LINCOLN CITY/LANCASTER COUNTY PLANNING STAFF REPORT

PROJECT #: Special Permit No.531F

PROPOSAL: To amend the Salt Valley View Community Unit Plan to add 162 dwelling units.

SITE PLAN

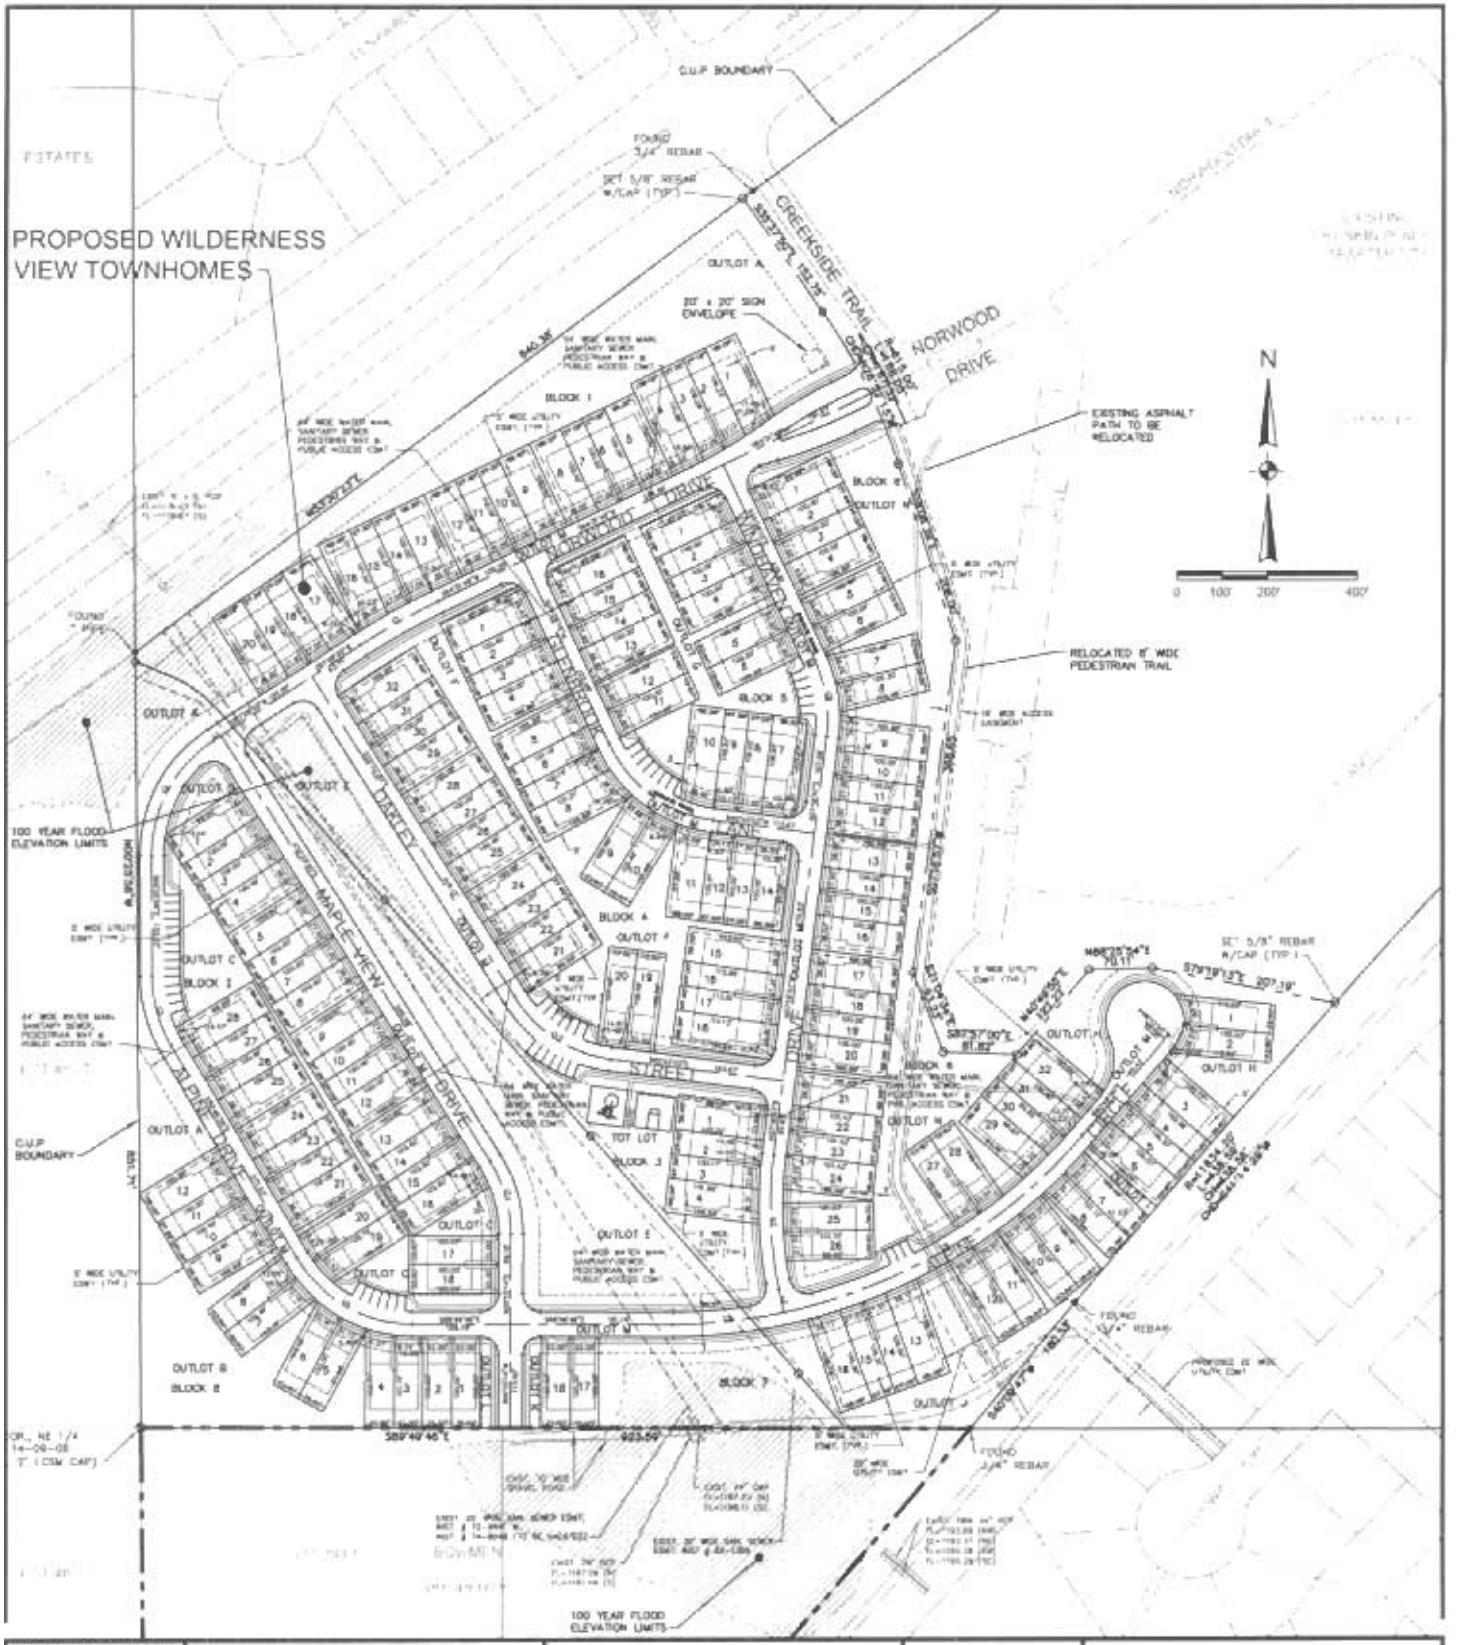
(3.1) The grading and drainage plan indicates that the proposed culverts under Alpine Drive back up water over a large portion of the property to the south of this development. This developer needs to obtain a flowage easement over this area from the adjacent property owner or the drainage system needs to be redesigned such that the adjacent property is not impacted.

(3.3) The grading plan indicates grading outside the boundary of this plat on the property to the south near the south end of Mapleview Drive. Written proof of agreement from the adjacent property owner for this grading needs to be provided or the grading plan needs to be revised to show no grading on the adjacent property.

(4.1) The conceptual secondary access shown at the northeast end of the site on sheet 2 of 8 is not satisfactory to Public Works. Prior to the approval of any final plat for this development, proposed grading and paving plans for this drive connection and associated right turn lane in Warlick Boulevard need to be provided to the satisfaction of Public Works.

(4.2) The site plan needs to be revised to show a north/east bound right turn lane in Warlick Boulevard at Creekside Trail. This developer will be responsible for the construction of the turn lane due to the increase in traffic from this development.

TYPICAL LOT DETAIL-4 PLEX

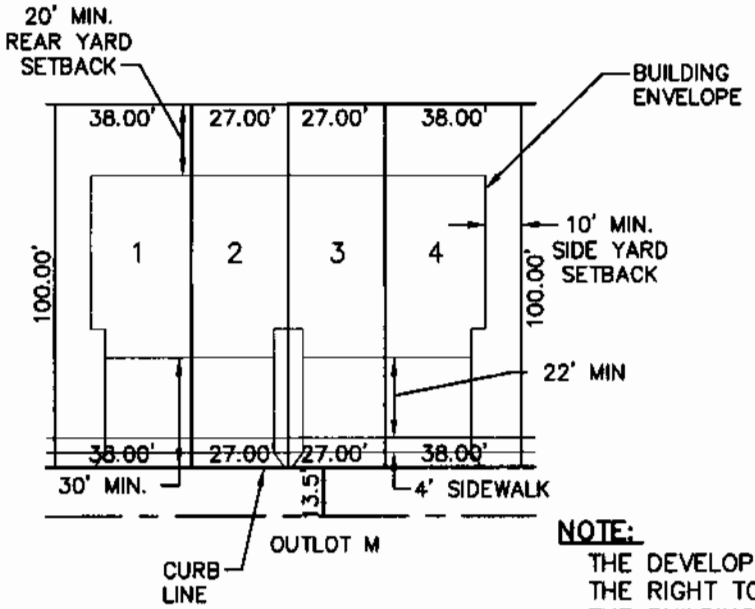
3.1.1.7 Change the 10' side yard setback to 5' in the Typical Lot Detail 4-Plex.

3.1.1.8 On Sheet 4 change 4-plex to townhouse and duplex to attached single family in the typical lot details.
